PLANNING REPORT

Architectural Review Board

48-52 S. High Door Replacements 25-072MPR

Existing Street View

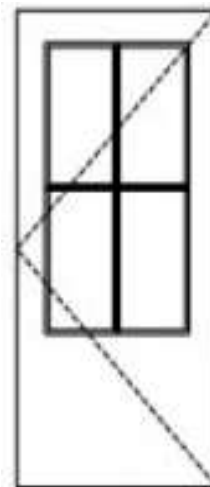
The Board recently approved modifications to the façade of 48 S. High Street to improve pedestrian access from S. High Street to the building. These modifications included the addition of a door and a storefront window (highlighted in yellow below). The applicant is now seeking

to replace the other existing door at 48 S. High, as well as two additional front doors at 50 and 52 S. High (highlighted in blue below). The proposed improvements will enhance the historic Landmark building.

The existing doors are not original to the building and were part of earlier storefront modifications. The proposed changes align with and match the recently approved door and are consistent with the historic character of the storefront, including size and architectural features. There will be no other modifications to the façade.
